TECHNICAL MEMORANDUM: COMPLETENESS REVIEW OF THE MINE OPERATING PERMIT APPLICATION

Black Butte Copper Project, Meagher County MT

February 5, 2016

Prepared by: Tom Myers, PhD, Hydrologic Consultant, Reno NV

Figure 1: Figure 1-4 from App D, Environmental Geochemistry Evaluation

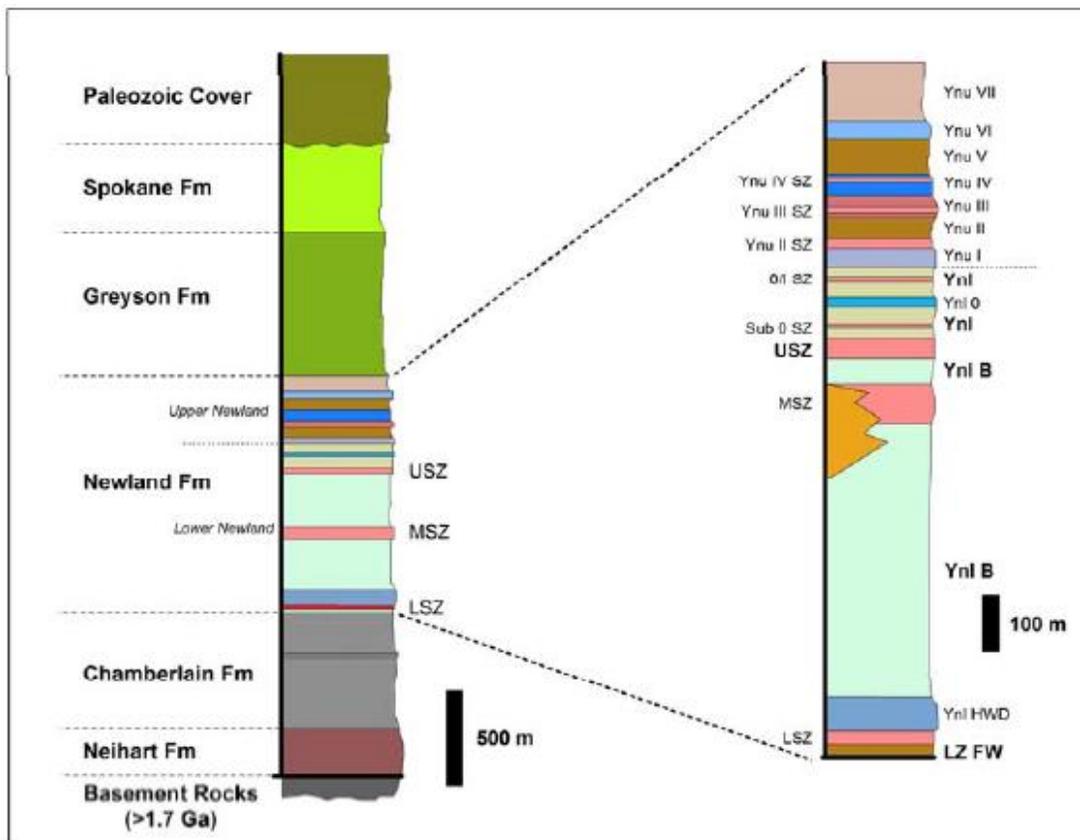
Tintina describes the basic stratigraphy, lithology, and structural geology of the site in Application section 1.4 and expands the description to include basic discussion of hydrogeology in section 2.2.3. These simple descriptions depict a highly complex stratigraphy with several dipping formations offset by several faults. Figure 1 summarizes the stratigraphy as discussed in the application. The monitoring and sampling regimes applied to this complexity have not been sufficient to characterize it.

Tintina reports that two well pairs, MW-1A/1B and PZ-07A/7B, have downward hydraulic gradients (Application, p 39), but does not provide a reference to water level data that can be used to

independently assess this data. The application notes that water level data is collected quarterly, but a search through the application and Appendix B found groundwater levels reported only on App B Figure 12, which shows “water level data from the May 2015 sampling round” (App B, p 2-14). Various tables show well completion data but no water level data and the well logs show depth to static water level for the monitoring wells during completion. The statement appears to be based on one observation or on data not otherwise presented in the Application or its appendices. The application is essentially missing key data for assessing flow directions and velocities.

Recommendation: In addition to other recommendations regarding collecting more water level data made elsewhere, the application should provide a table or an Excel spreadsheet with depth to water and water surface elevation for the monitored wells with time.

Figure 2: Figure 6 from Schulz-Makuch et al. (1999) showing the variation of hydraulic conductivity with volume of material used for testing. The Racine Formation a fracture-flow formation and is used here only as an example of the variability.

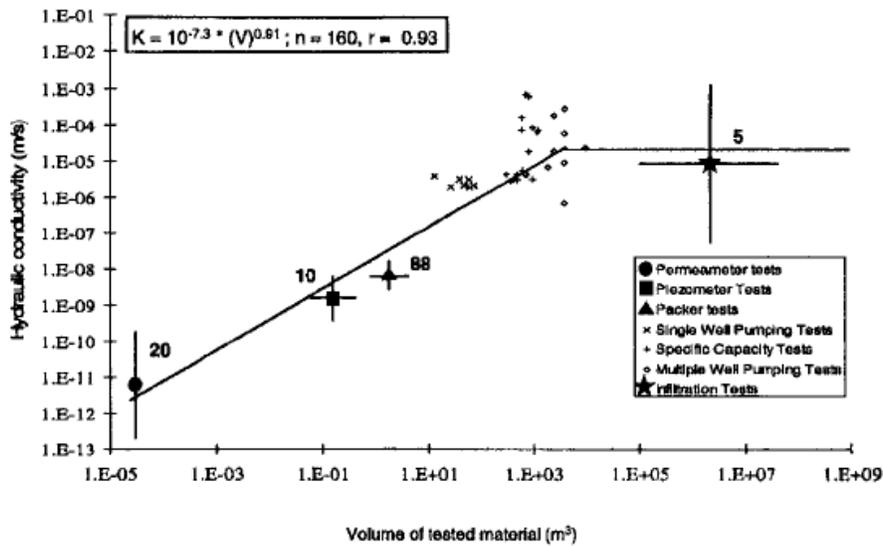
The application contains hydraulic conductivity data provided for a few short-term and longer-term pump tests for the various formations present near and potentially affected by the proposed mine. Short-term tests represent properties over only a very small volume. In general the representative volume is the amount of water pumped divided by the effective porosity (Schulz-Makuch et al. 1999); this effectively means a sample volume including all pore spaces affected by the pumping. Figure 2 shows an example from the literature of variability for a fracture-flow media, the type of media that controls the flow at Black Butte. Hydraulic conductivity varies over seven orders of magnitude in this

example; Schulz-Makuch et al. (1999) present data from other fracture flow examples. The single-well tests with water removed over only a few minutes presented in App B would have volumes similar to those presented for packer tests in Figure 2. The conductivity represented in Figure 2 for those tests is about four orders of magnitude less than that observed at the point where the relation becomes stable. Becoming stable means that conductivity is relatively constant even as volume is added to the sample for which K is being estimated. This is tantamount to the relative elemental volume concept which is the volume at which the effective porosity no longer changes as volume is added to the sample (Bear 1979). However, if sufficient additional volume is added to the sample, the conductivity will again vary with volume because it will begin to include an influence from surrounding formations. From the perspective of flow and transport prediction, the small-scale measurements control local flow while the larger-scale measurements control regional flow, which can be estimated without understanding localized details. A mine that intersects and excavates significant portions of a formation affects flow at a regional level and therefore needs property measurements at that scale. Tintina presents just two large-scale pump tests that may provide a property estimate at the scale necessary to estimate the effects of dewatering.

Recommendation: The recommendation above was for Tintina to establish many more groundwater monitoring wells and deep piezometers to improve the development of groundwater contours for all formations and all significant aquifer levels within those formations. New wells should be located also based on the need to determine aquifer properties for different formations at different aquifer levels, since properties change with depth. Tintina should perform pump tests designed to estimate aquifer properties in all flow zone identified by well logs and geophysical logs performed as recommended above.
